SERVICE BULLETIN

SB No. 130 Issue No. 1

TITLE INSPECTION OF RUDDER PEDALS FOR ADJUSTMENT RESTRICTION
CLASSIFICATION

Fig 1
VIEW ON RUDDER PEDAL SLIDER HOUSING

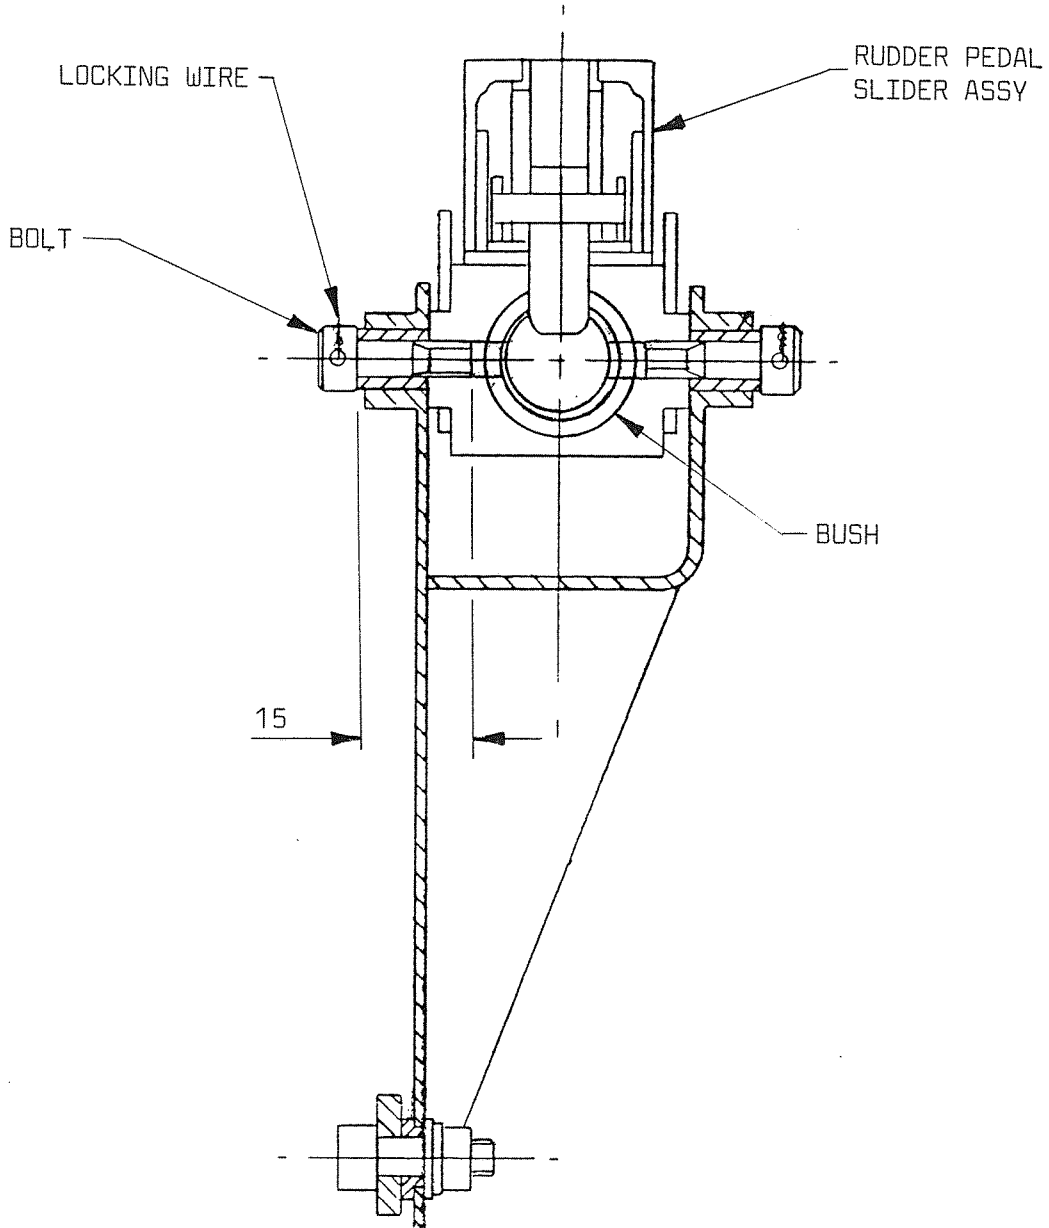
A case has been reported of the pivot bolt fouling the rudder pedal slider assembly, preventing proper adjustment.

1. Inspect the rudder pedal assembly and check for full, free and smooth movement of adjustment slider.
2. If slider movement is restricted or appears stiff, inspect slider bush and pivot bolts for any visual signs of fouling, ref. Fig. 1.
3. If fouling occurs, adopt the following procedure:
 - i) Remove bolt or bolts that are fouling and shorten by 1mm to 15mm nominal length from bottom of head. Etch prime the cut face of the bolt.
 - ii) Ream out internal diameter of bush to 16.00mm - 16.05mm to remove any deformation caused by fouling.
 - iii) Replace shortened bolt and renew locking wire.
4. Alternatively, invoke Mod M808 to replace all pivot bolts.
5. Annotate log book "SB 130 complied with".
